LuK Service Info

TB1278

Manufacturer: RENAULT

Model: CERES, CERGOS & ERGOS

**Flywheel
Schwungrad
Volant – Moteur
Volante – Motor
Volano**

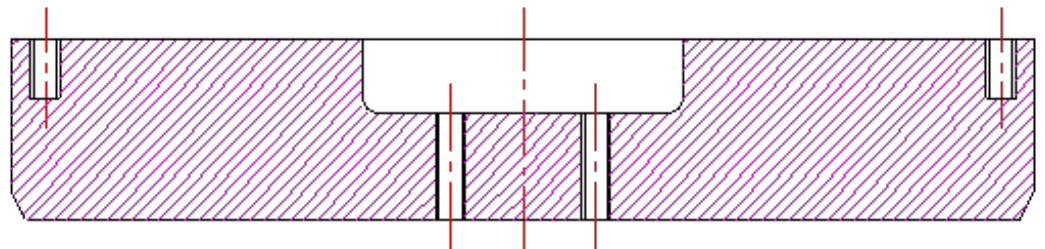
Replaces LuK 328 0373 10 for applications with single clutch 131 0284 10. The new disc is of increased diameter. Please ensure that the flywheel is machined to a flat face.

Flywheel
Schwungrad
Volant – Moteur
Volante – Motor
Volano

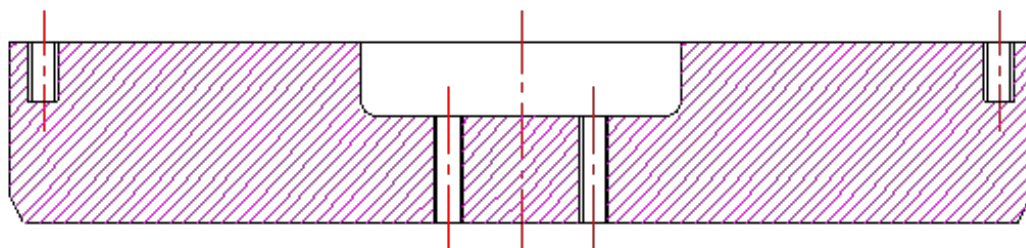
Please ensure that the flywheel is machined to a flat face.
